**GEOTECHNICAL REVIEW  
OF THE STATUTORY ENVIRONMENTAL  
ASSESSMENT (EA) FOR  
VACHERIE SALT DOME SITE  
WEBSTER AND BIENVILLE  
PARISHES, LOUISIANA**

**DRAFT FINAL REPORT**

**LOUISIANA DEPARTMENT  
OF ENVIRONMENTAL QUALITY**

**FRANCIS S. KENDORSKI, P.E.**

Figure 4.1-2. Line ELV-S2. Adapted from Ertec (1984, ONWI-520, Fig. 4-5).

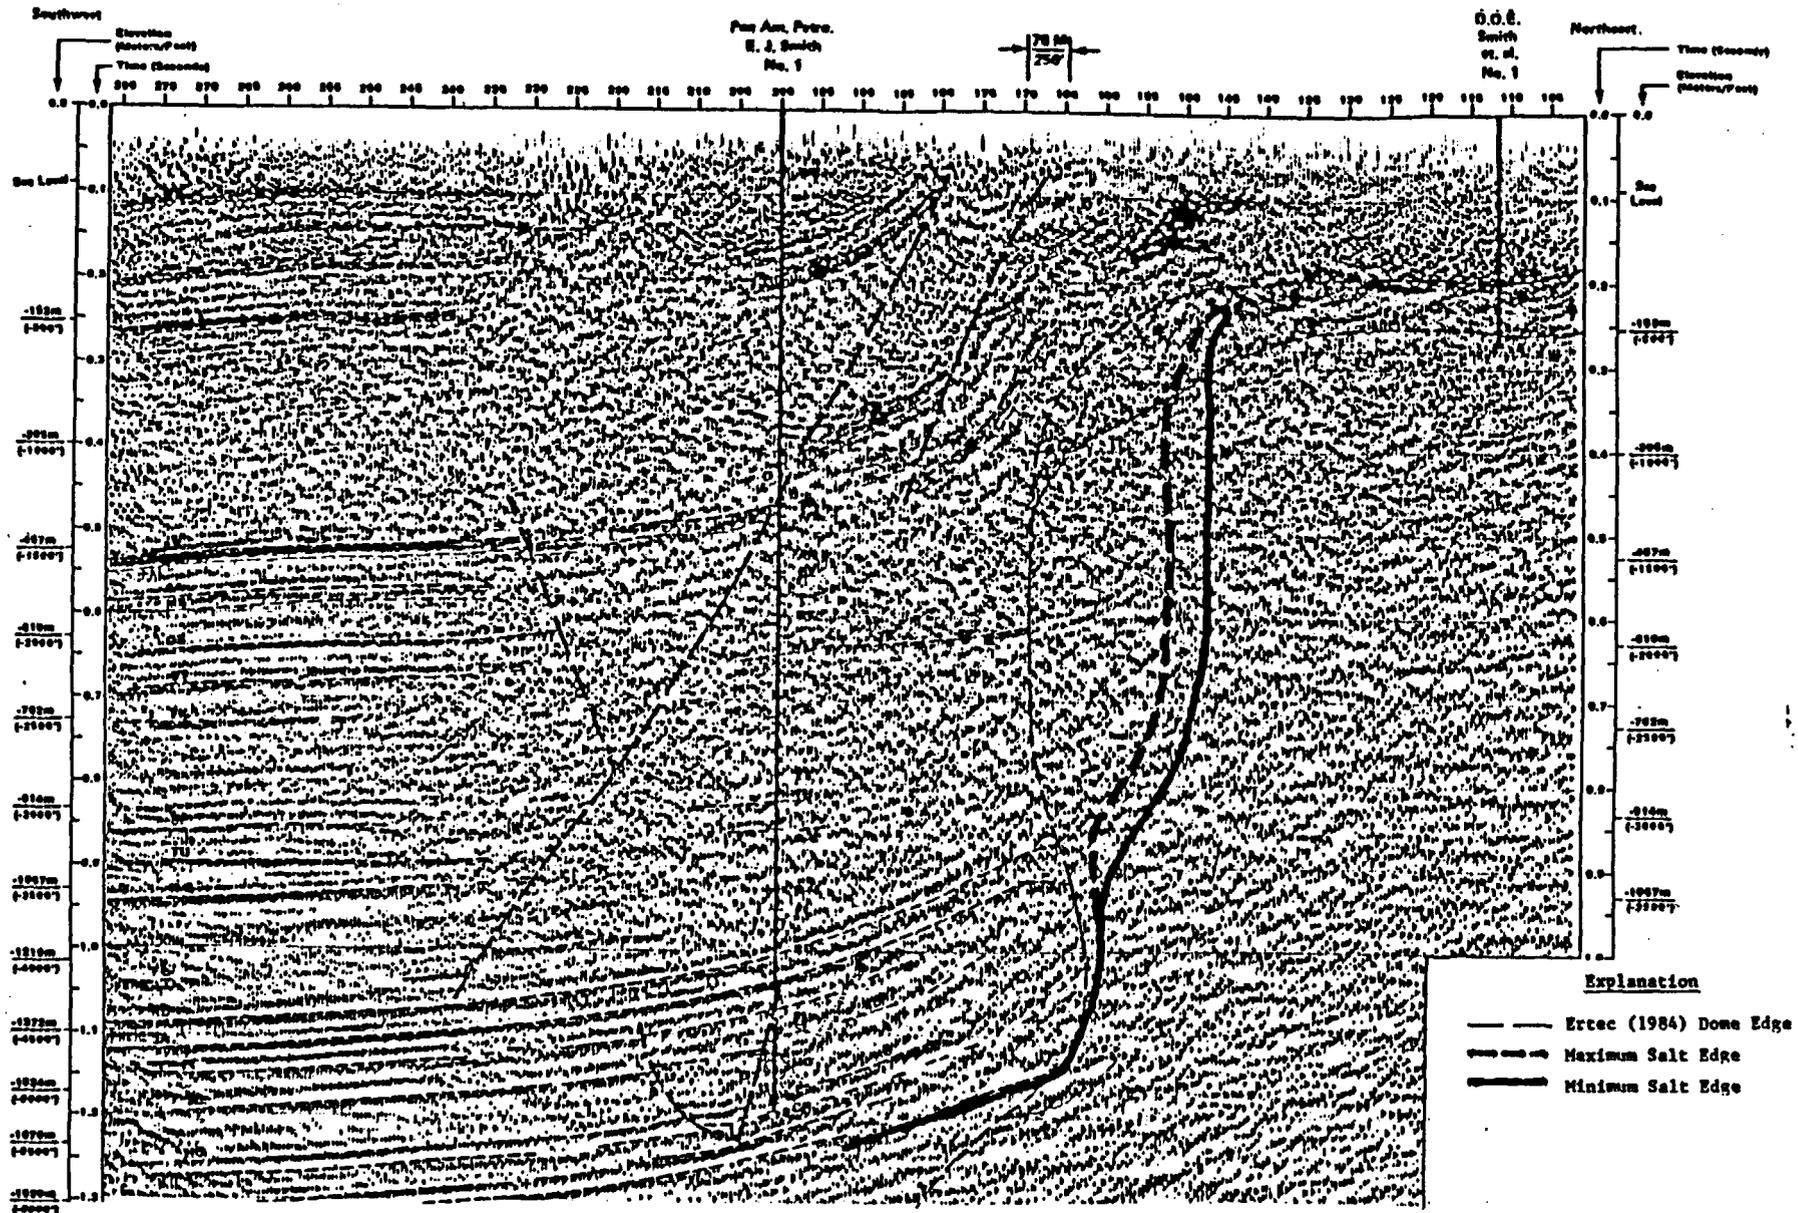
#### 4.1.4 Conclusions

The Ertec interpretations of domal area are much higher than those interpreted in this report. Total available area at -3,000-ft MSL ranges between 910 and 1,280 acres, excluding the 800-ft buffer zone. These estimates of available domal area are far below the 1,500 acre minimum used by ONWI (1982, ONWI-109, p. 41) to eliminate salt domes from consideration for nuclear waste

Figure 4.1-5. Interpreted -3,000 ft MSL salt stock edge contour lines. Adapted from Ertec (1984, ONWI-520, Fig. 1-2).

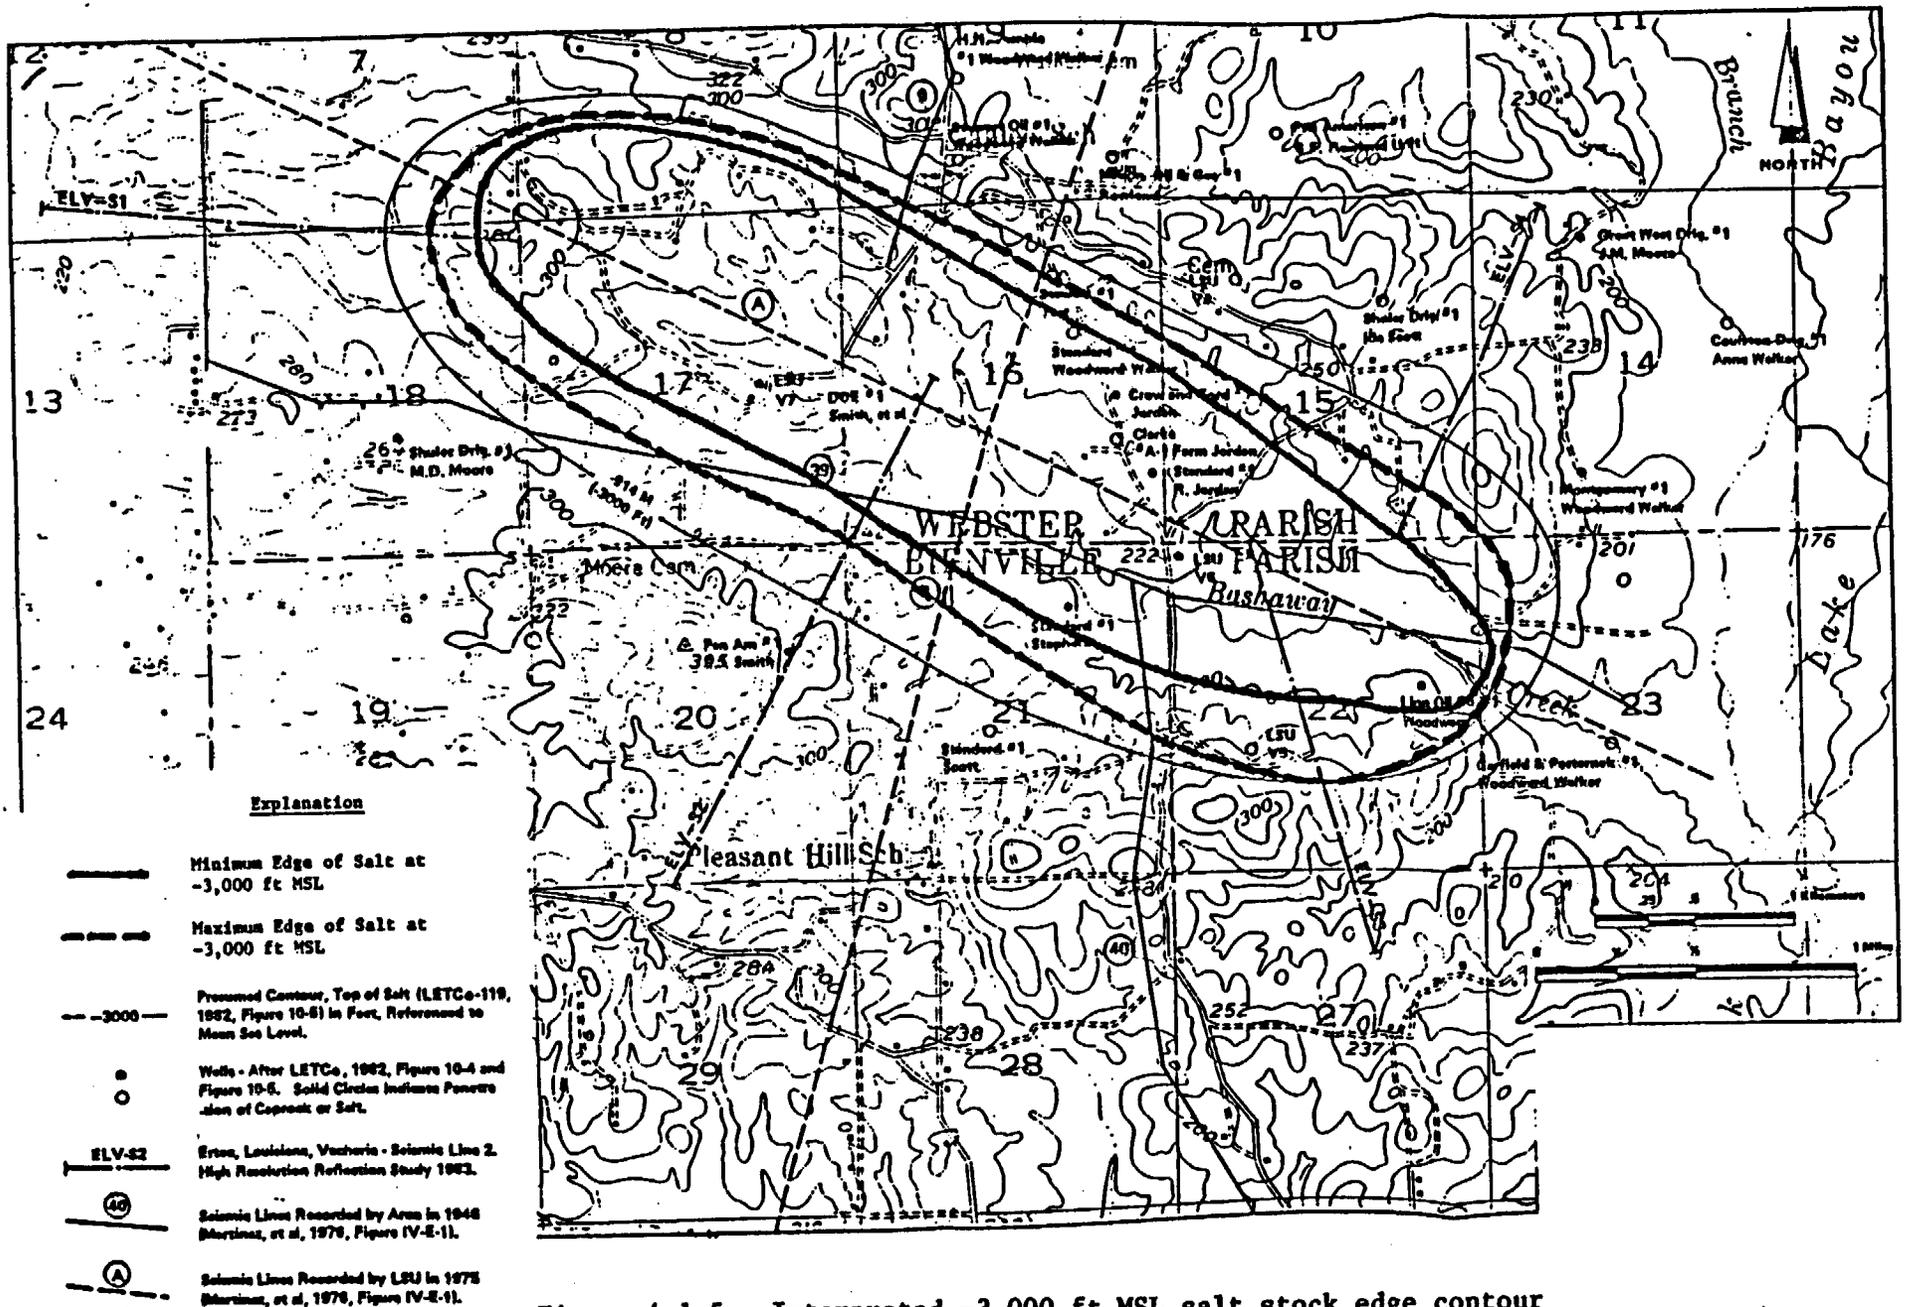
repositories. Vacherie Dome should be eliminated from further consideration for use as a repository.

Figure 4.7-1 - Flow Chart of the Site Screening Process

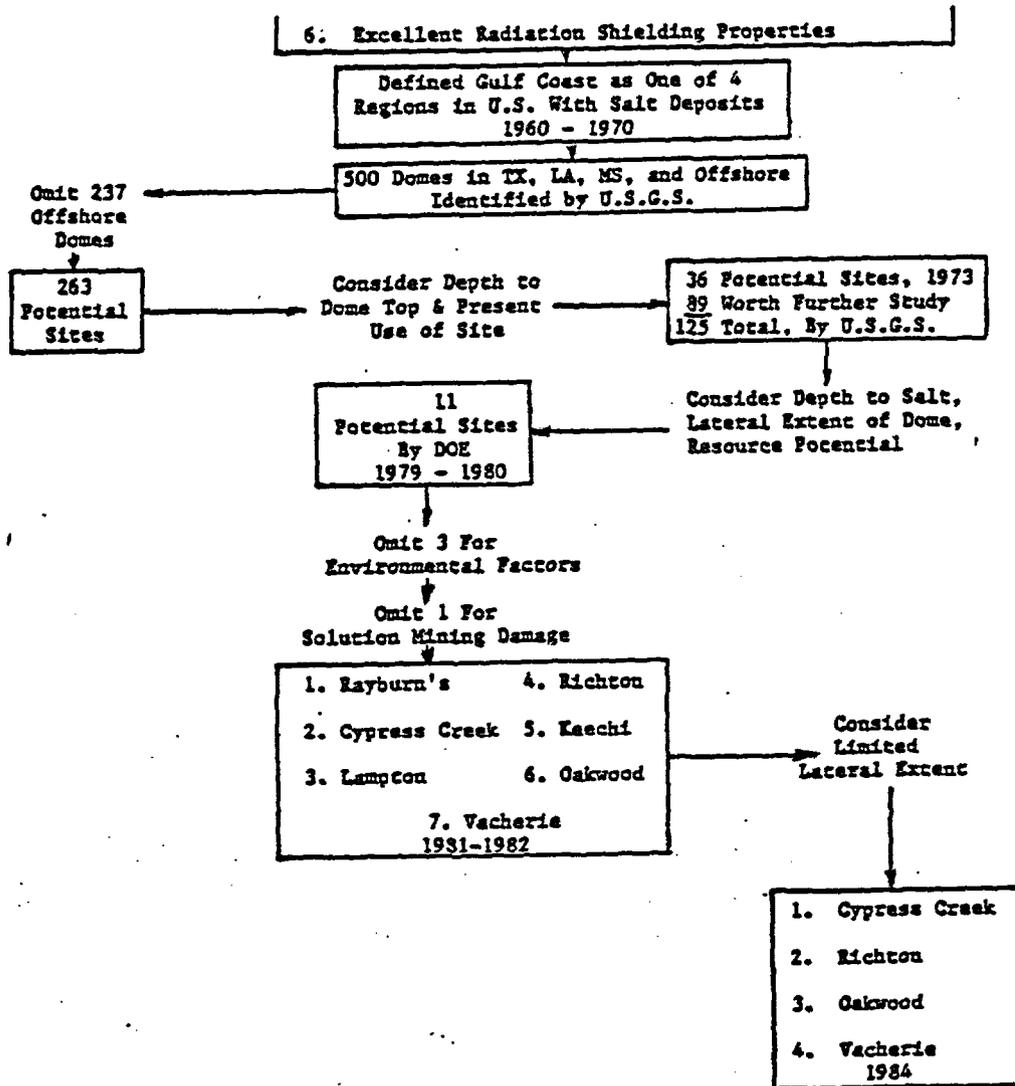
Figure 4.7-1 illustrates the screening history. However, the execution of the site screening process has not been consistent. Screening has included some arbitrary decisions, that is, equal application of siting criteria has not been applied equally to all sites.

Vacherie is still included as a potential site despite its limited lateral extent, justified by a proposed multi-level repository. This "solution" should then requalify other sites that were eliminated from consideration because of limited lateral extent. The NWPA does not exclude site re-evaluation based on changing siting criteria.
